PLANNED UNIT DEVELOPMENT &

SUBDIVISION STAFF REPORT Date: July 15, 2004

NAME Professional Associates Subdivision

LOCATION 801 South University Boulevard

SITE PLAN

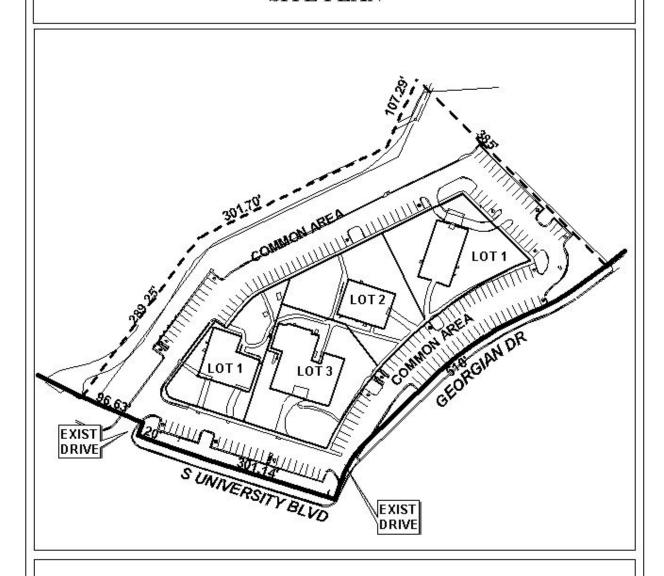
REMARKS The applicant is proposing the subdivision of an existing commercial development consisting of four single-story masonry buildings and associated parking facilities into four lots (one for each office facility) and a common area (which will contain all parking and access).

As stated above, the purpose of the applications is to subdivide the site into four lots (one for each existing building) with the parking area as common area with common ownership. Initially, no noticeable change is proposed – simply the creation of separate lots to allow the building owner to also own the land. The site development has existed in this configuration for a number of years.

There are no immediate plans to redevelop the properties; therefore, as PUD approval is site plan specific, a new PUD will be needed if redevelopment does occur in the future. Any necessary reconfiguration of parking and access can be addressed at that time.

Also, it has been the practice of the Commission to require some level of compliance with landscaping and tree plantings, and to require installation of sidewalks when granting applications for PUD approval. In this instance, there are numerous trees located on the site (and adjacent in the right-of-way). However, the plan submitted does not provide information relating to the amount of existing landscaped area or numbers and types of trees located within the site. Therefore, coordination with the Urban Forester to achieve compliance would be appropriate.

Another point that can be addressed through the PUD relates to signage. Presently there is a sign on Georgian Avenue that is located in the right-of-way. The Zoning Ordinance requires that all signs be located on private property. While the sign has been in the right-of-way for a number of years, it should have already been relocated regardless of any conditions of approval.

RECOMMENDATION Planned Unit Development: based on the preceding, it is recommended that this application be approved subject to the following conditions: 1) documents establishing a property owners association and specifying the responsibility and

method of maintenance of all common areas be prepared and recorded in Probate Court (documents to be reviewed and approved by the Commission's attorney prior to recording); 2) relocation of the sign located in the right-of-way onto private property (proper permitting required); 3) compliance with the landscaping and tree planting requirements of the Ordinance, to be coordinated with the Urban Forester; and 4) full compliance with all municipal codes and ordinances.

Subdivision: based on the preceding, it is recommended that this plat be considered an innovative subdivision and granted Tentative Approval subject to the following conditions: 1) placement of a note on the final plat stating that maintenance of the common area to be the responsibility of the property owners association) and 2) documents establishing a property owners association and specifying the responsibility and method of maintenance of all common areas be prepared and recorded in Probate Court (documents to be reviewed and approved by the Commission's attorney prior to recording)
